Pre-Decisional Enforcement Conference Inspection Report 07201014/2022-201

Agenda

MPC-37 Variants

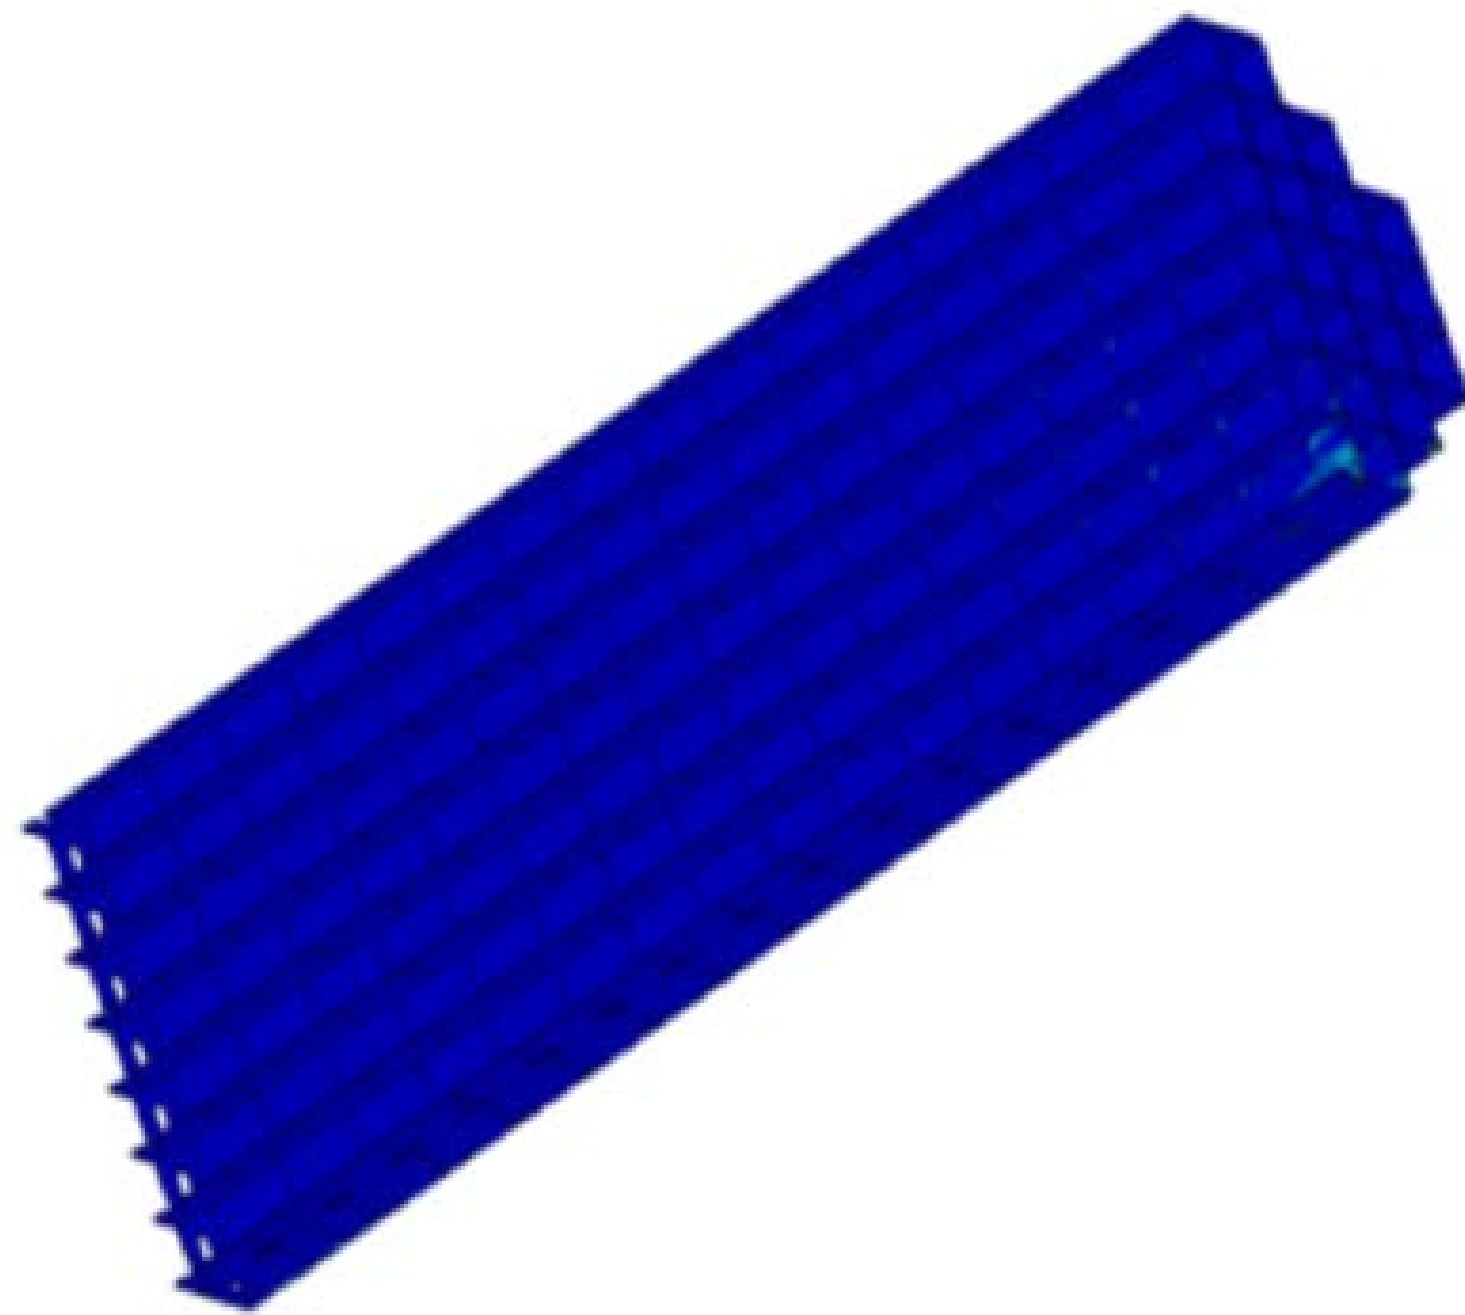
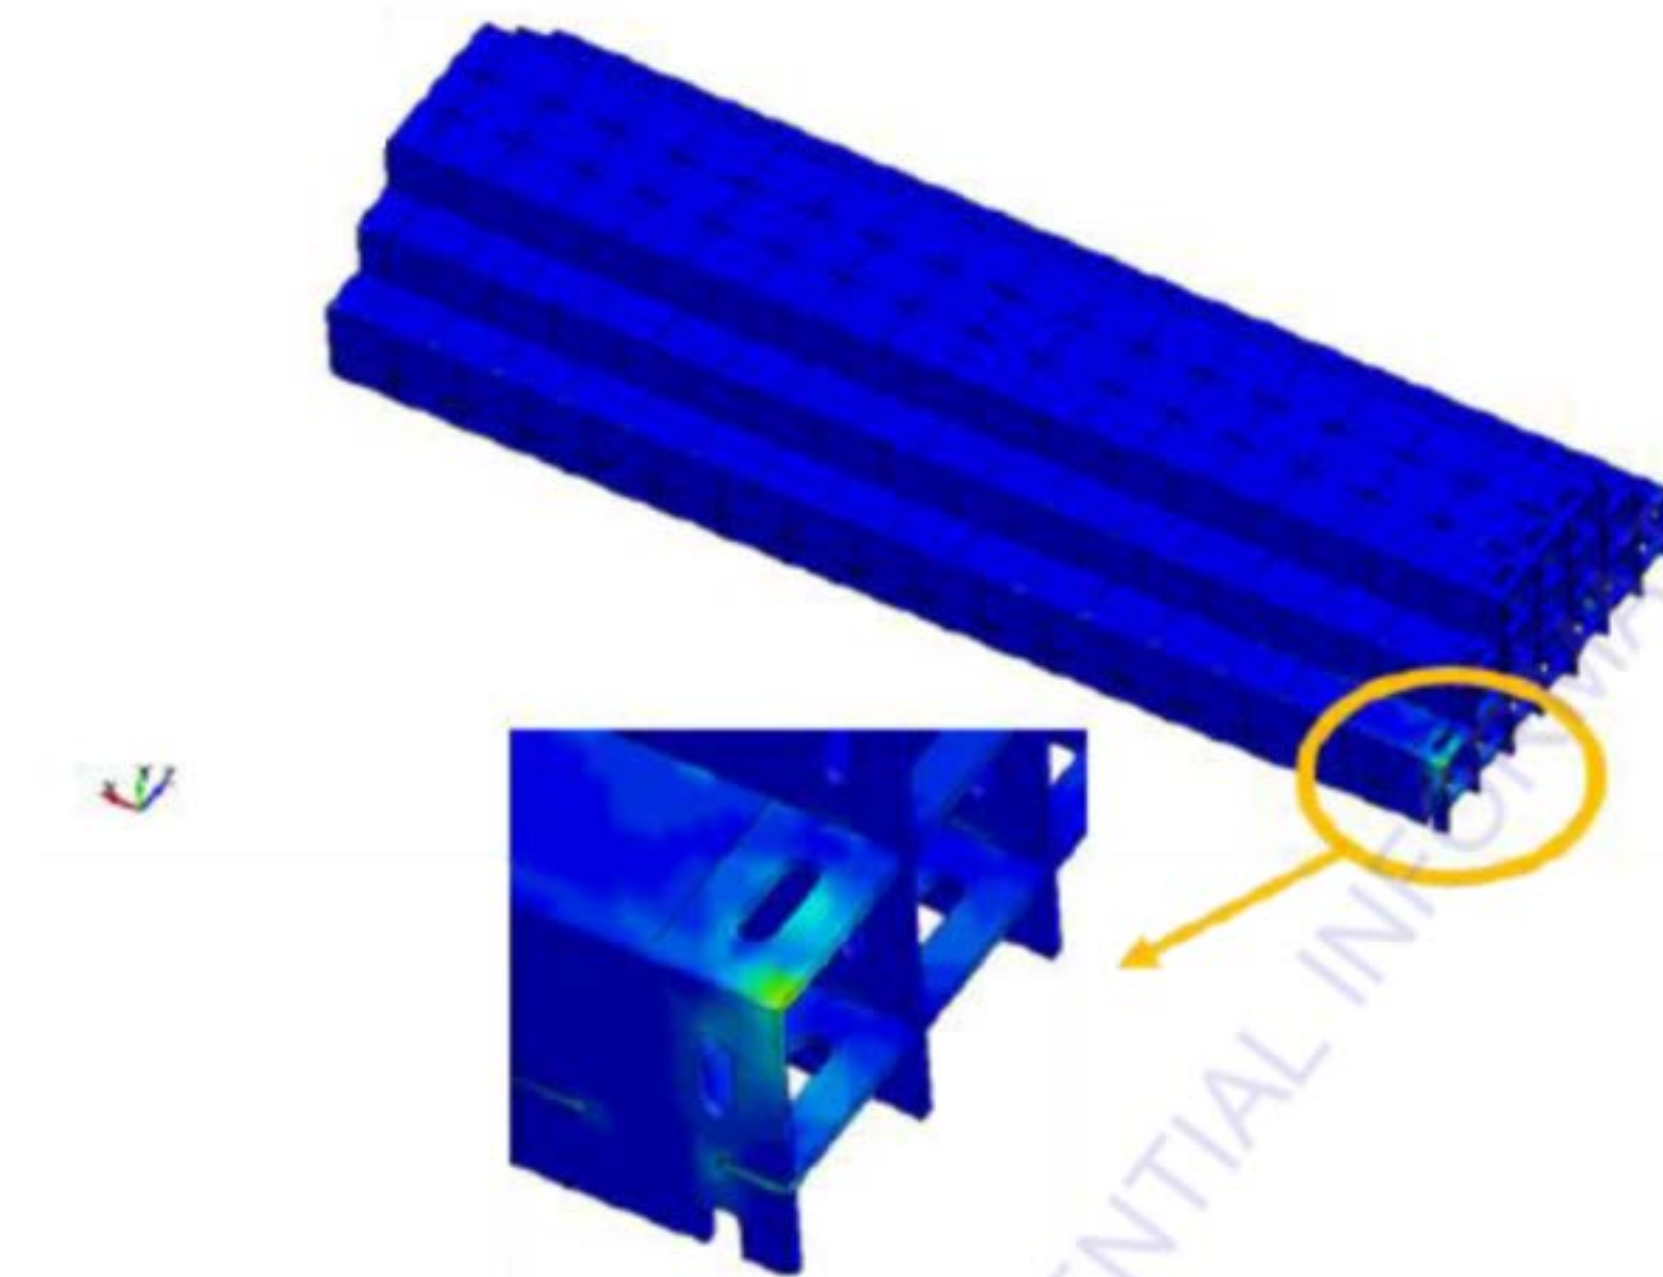
- “8) FSAR HI-2114830, revision 7, section 3.4.4.1.4b, states that lateral deflections from the tip-over analysis of the CBS basket comply with the deflection criterion in FSAR table 2.2.11. However, Holtec did not include lateral deflections of the CBS fuel basket design of the FSAR. Instead, Holtec documented that the maximum local plastic strains of the 89-CBS basket reached the rupture strain and depicted small plastic deformation in the active fuel region. For the 37-CBS basket, Holtec reported the maximum local plastic strains and provided figures of the maximum plastic strains, which showed small plastic deformation in the active fuel region of the MPC 37-CBS basket. Despite these results, Holtec incorrectly concluded that the fuel baskets did not experience any permanent deformation in the active fuel region in appendix N of HI-2094353. **The team considered this a different MOE because Holtec stated there was no plastic deformation. However, the changes being considered now show plastic deformation.**

■ Response to Item 8

- ✓ We submit that this is NOT a change in methodology – the results in the FSAR for the MPC-37-CBS basket are the same as those presented for the original design of the MPC-37
- ✓ The Holtec FSAR presented strain results in figures for the MPC-37
- ✓ For the MPC-37-CBS basket figures were also included in the FSAR to show strain results throughout the basket
- ✓ For both the original and CBS basket designs, the FSAR figures support the **same conclusion** that the basket meets the structural basket criteria
